Office Action Summary	Application No. 10/592,028	Applicant(s) LEE ET AL.	
	Examiner JEFFREY ALLEN	Art Unit 3781

DETAILED ACTION

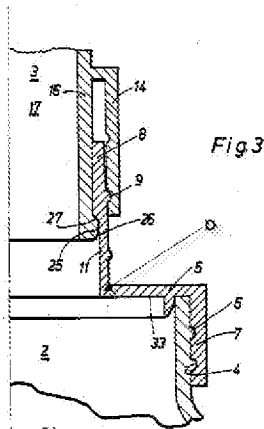
6. Goncalves teaches all the claimed limitations as shown above and wherein the exhausting pieces have a bending portion. In the present embodiment Goncalves fails to teach wherein the exhausting pieces are inserted between an upper end of the inner cap body and a lower end of the storage tube.

7. In an alternate embodiment Goncalves teaches wherein the exhausting pieces are inserted between an upper end of the inner cap body and a lower end of the storage tube (Fig. 5).
